Section 404/401 and Article 24 Permit Application – Residuals Management Unit No. 2

Response to NYSDEC email comments dated October 16, 2013

CWM RESPONSE TO COMMENTS SECTION 401/404 AND ARTICLE 24/PART 633 JOINT APPLICATION JULY 2013 SUBMITTAL

New Drum Building Design Drawing (dated December 7, 2011) Revised New Drum Building Design Drawing C-5 (dated May 30, 2013) Revised New Drum Building Design Drawing (dated October 22, 2013)

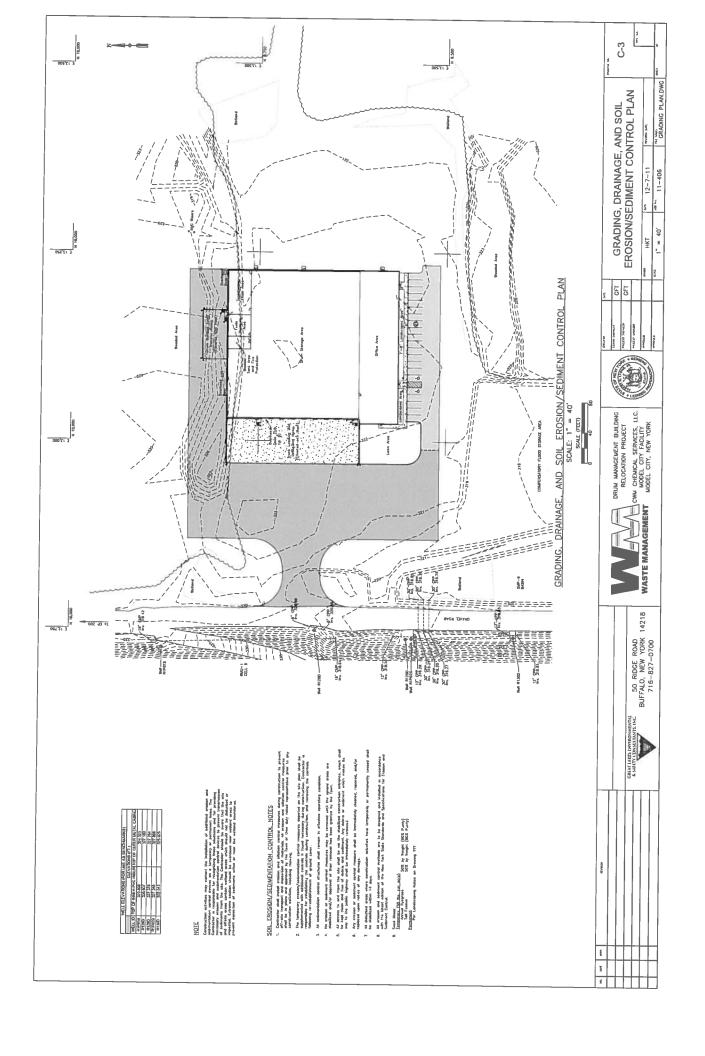
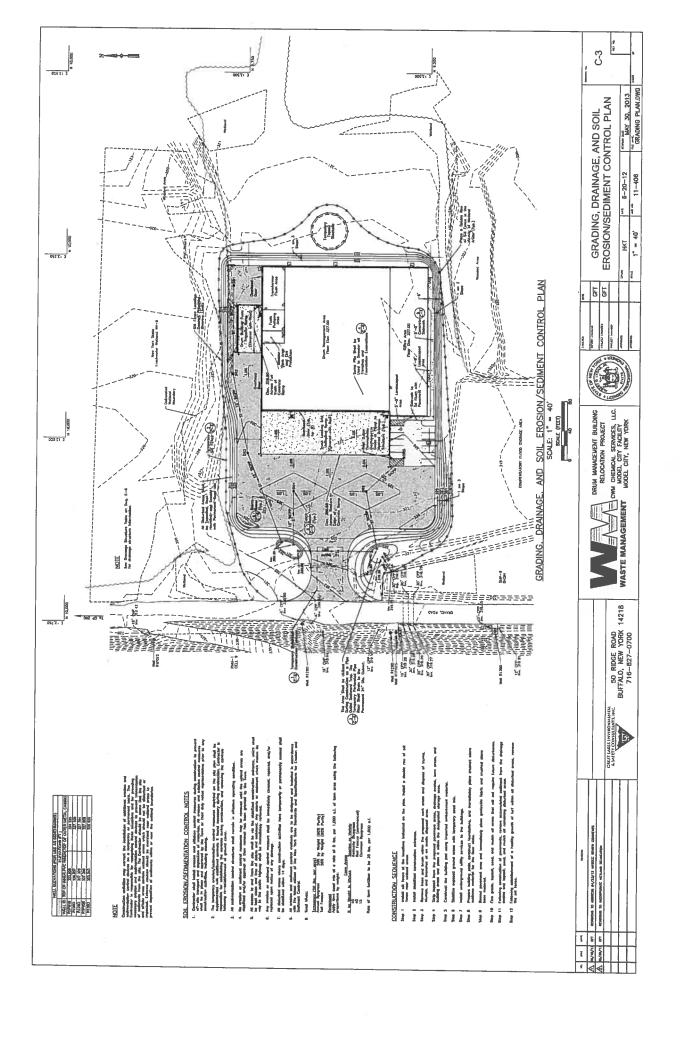
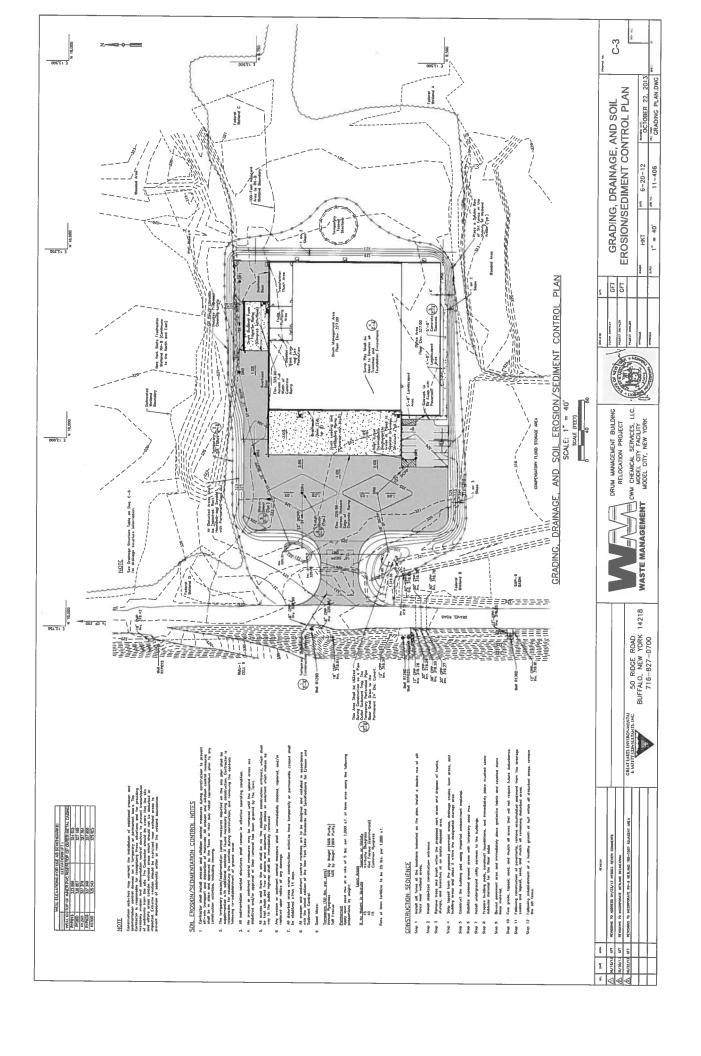
The revisions made to the Building footprint following my November 2012 site inspection (which extended the Wetland RV-8 boundary a few hundred feet south), are helpful. However, before I can be comfortable accepting that CWM minimized impacts to the adjacent area at this location (and therefore potential risks of impacts to Wetland RV-8), I need more details demonstrating that CWM down-sized the footprint of the Building and shifted it southward (away from Wetland RV-8) to the greatest degree practicable. I saw nothing in the Sept 25, 2013 letter to the Corps (or other project material) that specifically addressed that.

Please check on the accuracy of the Wetland RV-8 delineation boundary in relation to the topographic contours and building footprint shown on the revised (May 30, 2013) plan as it simply doesn't look right. I clearly recall the wetland configuration I inspected on November 6, 2012 and am sure the southern boundary did not extend uphill as much as 5 feet along the north side of the existing fill piles. I am afraid that the EDR flagging was placed at the south edge of the very thick shrub growth on the fill piles instead of at the toe of the fill piles where the wetland boundary truly ends. While that would normally not be a major concern for a project placed outside the wetland proper, it is fairly significant for a project built very close to the wetland boundary where the applicant needs to maximize remnant buffer. EDR and/or I may need to revisit this (potentially with another field inspection by EDR to refine the wetland boundary). Please first verify the shapefile accuracy.

Therefore, CWM redesigned the location of the building and redesigned the driveways, parking areas, grading plan, and stormwater management features. A parking area was originally located on the south side of the building. For the redesign, the parking area was shifted to the southwest corner of the building. Additionally, the landscape area south of the office portion of the building was reduced in size. Consequently, the north to south footprint dimension of the building and paved areas was reduced by approximately 52 feet. Additionally, the south boundary of the building footprint/paved area was shifted approximately 62 feet to the south. The building and paved area footprint was moved as far south as practicable without filling federal wetlands and the compensatory flood storage area for 12-mile creek.

The current DMB design will not impact freshwater wetland RV-8, however, the 100-foot adjacent area will be impacted. The 100-adjacent area that will be impacted includes mostly open field areas. The location of the DMB cannot be further moved to the south because to do so would directly impact a federal jurisdictional wetland, a compensatory flood storage area for Twelve Mile Creek, and stormwater management point No. 9 (SMP09). See attached drawing for a revised grading plan design with a revision date of October 22, 2013.

CWM checked with design engineer for the new DMB (Great Lakes), the firm that performed a detailed survey of the area (Ensol, Inc.), and EDR for the accuracy of the RV-8 boundary. Apparently, the GPS shapefiles from EDR were not placed accurately on the design drawing prepared by Great Lakes due to software transfer issues. It was confirmed that the boundary of the RV-8 wetland boundary on new DMB drawing C-3 (dated May 30, 2013) is not accurate. Therefore, the boundary of RV-8 has been revised as shown on revised DMB Drawing C-3. Consequently, there is additional buffer area between the new DMB building development and Freshwater Wetland RV-8. CWM does not feel that it is necessary for further field verification at this time.

New Drum Building Design Drawing C-5 (dated June 11, 2013)

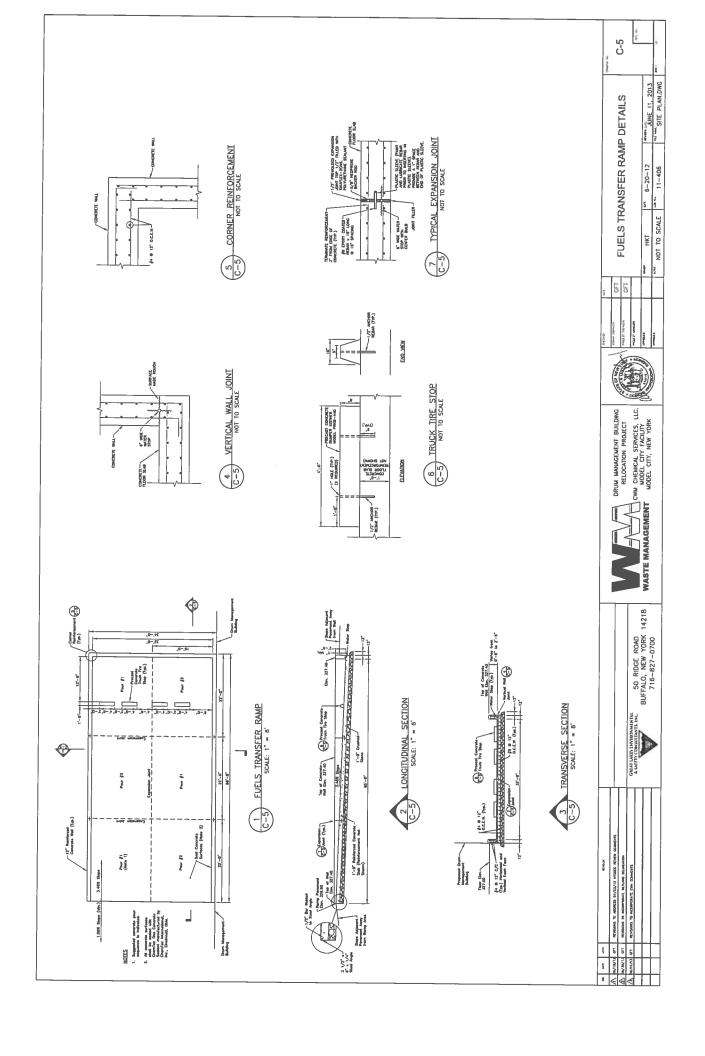
It is essential that CWM maximize the buffer width at this location, especially considering the nature of this facility. For example, I believe there are real concerns about the potential risk for discharge into the wetland when the "Drum Building Fuels Transfer Ramp" along the north side of the building is <50 feet from the Wetland RV-8 boundary, as shown on the revised grading plan. CWM needs to clearly explain how will those risks be minimized.

The Drum Building Fuels Transfer Ramp will be a Part 373 Permitted Container Storage Area. the design of the Fuels Transfer Ramp is provided on Drawing C-5 included in Attachment D of the Part 373 Permit Modification Application/Request for RMU-2 (August 2013). The Part 373 Permit Modification Application/Request also includes regulation required secondary containment calculations. Secondary containment will be provided by a sloped concrete ramp. An approved sealant, (e.g., CHEMTEC One) will be applied to the concrete area of the ramp. This ramp will be used to transfer compatible liquids from drums inside the new DMB to bulk tankers located on the ramp. The ramp is sized to accommodate two tankers to also allow the transfer from tanker to tanker. The dock area will be covered with a roof, to minimize stormwater accumulations and to provide protection for personnel during inclement weather. Any spills that may occur in the fuels ramp will be contained by the secondary containment. The ramp is inspected daily and during transfer operations. Any potential spills within the secondary containment of the ramp will be cleaned up immediately in accordance with the Part 373 Permit. Any accumulations of stormwater within the secondary containment of the ramp must also be removed within 24 hours of the end of a storm event in accordance with the Part 373 Permit. Therefore, there is minimal or no risks of liquids from the fuels transfer ramp to enter Wetland RV-8 or the stormwater management system.
